2. SITE CHARACTERISTICS

2.1 Introduction

Figure 2.2.1-1 Major roads, railways, and gas pipelines in the vicinity of the ESP site

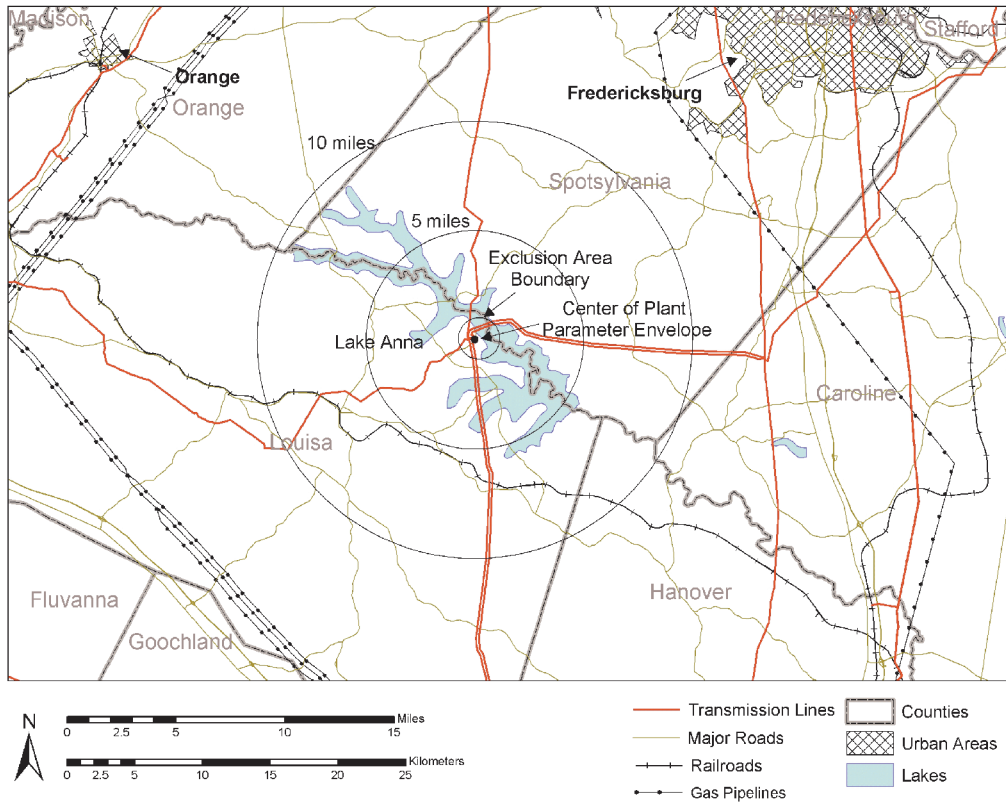
In Section 2.2.2.7 of the SSAR, the applicant stated that no oil or gas pipelines are located within 5 miles of the proposed ESP site. Similarly, in Section 2.2.2.8 of the SSAR, the applicant stated that no military facilities exist within 5 miles of the proposed ESP site. Figure 2.2.1-1 illustrates the locations of nearby major roads, railroads, and gas pipelines relative to the ESP site.
